UNITED STATES PATENT AND TRADEMARK OFFICE

Office Action Summary

10/828,503

SUZUKI ET AL.

Figure A

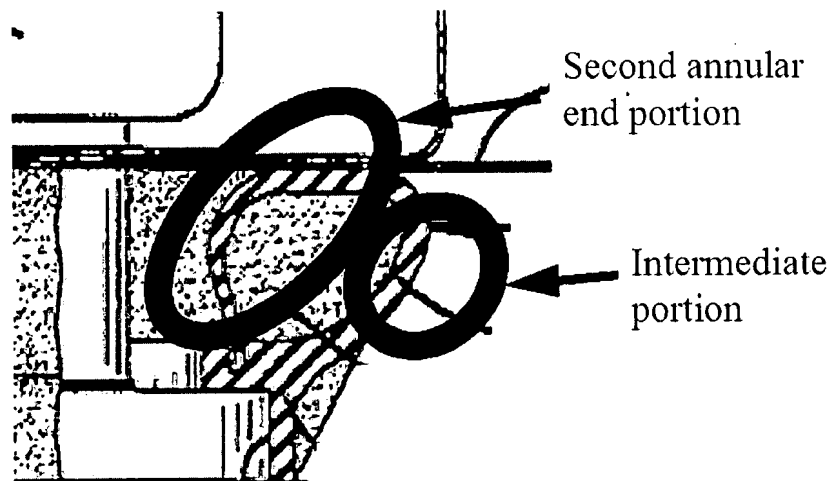
a. A column hole cover 4 interposed between a circumferential portion of an aperture of a column hole formed at an instrument panel 1 for insertion of a steering column 16 therethrough and a steering gear box 2 capable of being displaced in a predetermined direction, the column hole cover comprising: a cylindrical main body 5 extended in the predetermined direction, and being formed as a single cylinder having a center axis, the single cylinder of the main body including a first annular end portion 8 directly or indirectly fixed to the steering gear box, a second annular end portion (see Figure A of this Action), and an intermediate portion (see Figure A of this Action) between the first and second end portions, the second end portion including an annular seal, the intermediate portion including an expandable/contractible portion capable of being elastically expanded or contracted in the predetermined direction, wherein, irrespective of the displacement of the steering gear box, the annular seal is maintained in an elastic pressure contact against the circumferential portion of

the aperture of the instrument panel by a reaction force of the compressed expandable/contractible portion (col 1, lin 39-50) (claim 1.)

- b. The annular seal is slidably movable along the circumferential portion of the aperture of the instrument panel in association with the displacement of the steering gear box (claim 2.)
- c. The maximum compressible amount of the expandable/contractible portion is designed to be greater than the maximum displacement of the steering gear box (col 1, lin 39-50) (claim 3.)
- d. The expandable/contractible portion has a predetermined amount of compression when the steering gear box is located farthest away from the circumferential portion of the aperture of the instrument panel (col 1, lin 39-50) (claim 4.)

- e. The annular seal including an annular flange, the annular flange including a confronting face in face-to-face relation with the circumferential portion of the aperture 12 of the instrument panel, the confronting face of the annular flange including at least one annular seal lip (fig. 1) (claim 5.)
- f. The expandable/contractible portion includes a bellows (claim 11.)
- g. The first end portion defines a first terminal edge of the single cylinder, and the second end defines a second terminal edge of the single cylinder (fig A above) (clm 18).
- h. The first and second end portions of the main body are end portions with respect to an axial direction of the main body (fig A above) (clm 19).
